AMENDMENTS TO THE DRAWINGS:

REMARKS

FIG. 1A

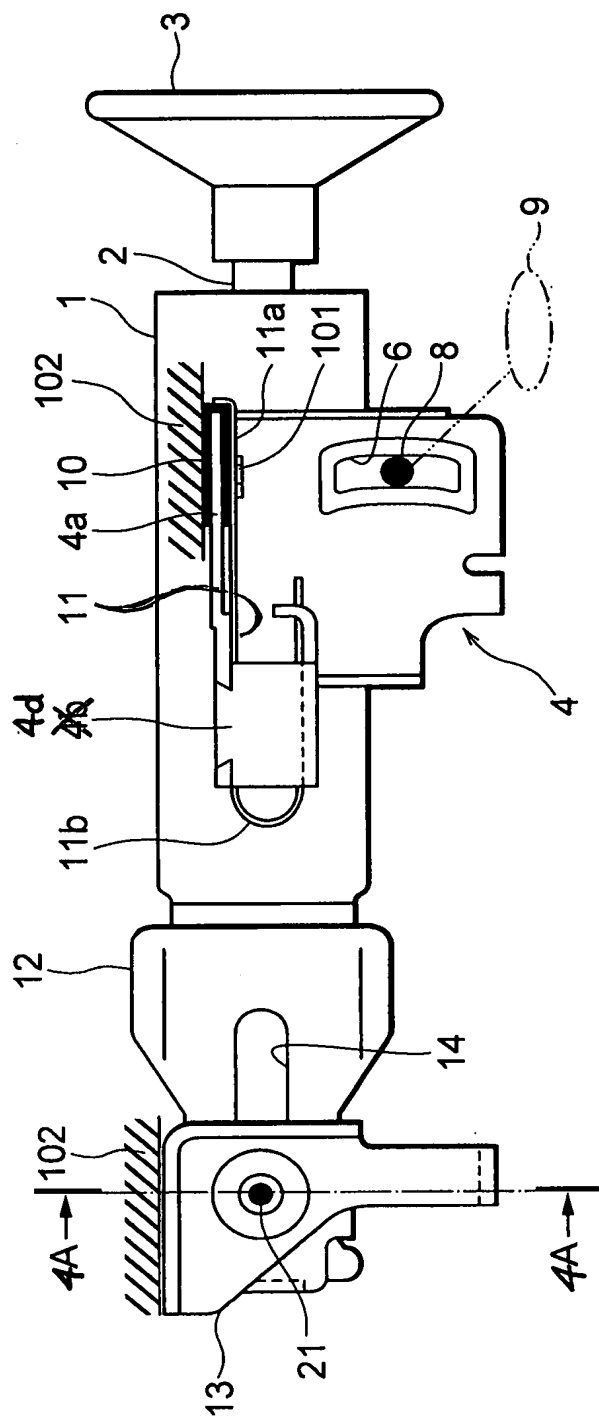
Please substitute the attached replacement sheets for Figures 1A and 5 of the drawings as originally filed. Annotated sheets showing the changes are also provided herewith.
